Addendum No. 3

RFP 21-06 WCC and LCC LED Monument Signs
Date: 11/02/2021

- d. Picture of existing monument sign:

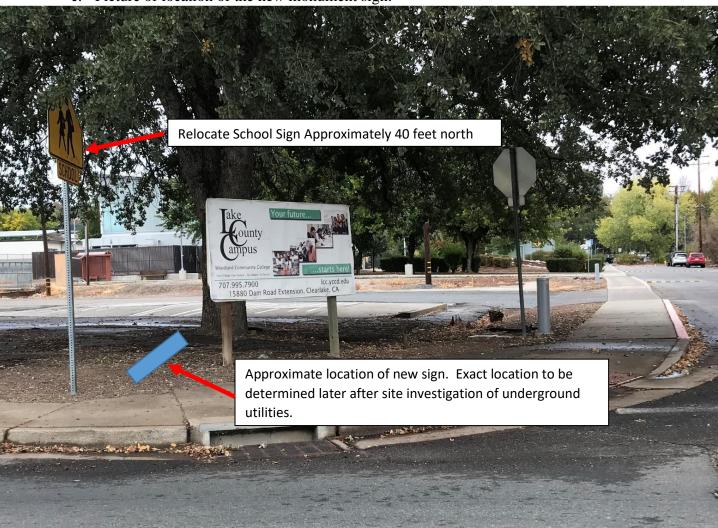
- 1. Woodland Community College Campus Monument Sign Size:
 - a. Existing Top Half Physical Size: 96" wide x 60" high
 - b. New Digital Top Half Physical Size and Matrix:

- i. GS6-80x150-15.85-RGB-2V (4'8" tall x 8'1" wide; cabinet dimensions)
 - ii. This new LED digital **10 mm sign** shall be on both sides of the sign to allow two direction viewing.

- c. Existing Bottom Half (Base) Size: 83" wide x 28-1/2" high
 - i. The bottom half (Base) shall have a new UV rated Vinyl Label / Sign adhered with the Standard WCC Logo similar to the existing sign. The Logo size shall be as large as possible on the base while still looking good. Colors to match existing sign/College colors.

- ii. The new Vinyl sign shall be removable if possible to be easily replaced every 5 years or so in case it fades or gets damaged.
 - iii. The existing Rotary sticker shall be removed on both sides before applying the new vinyl sign.
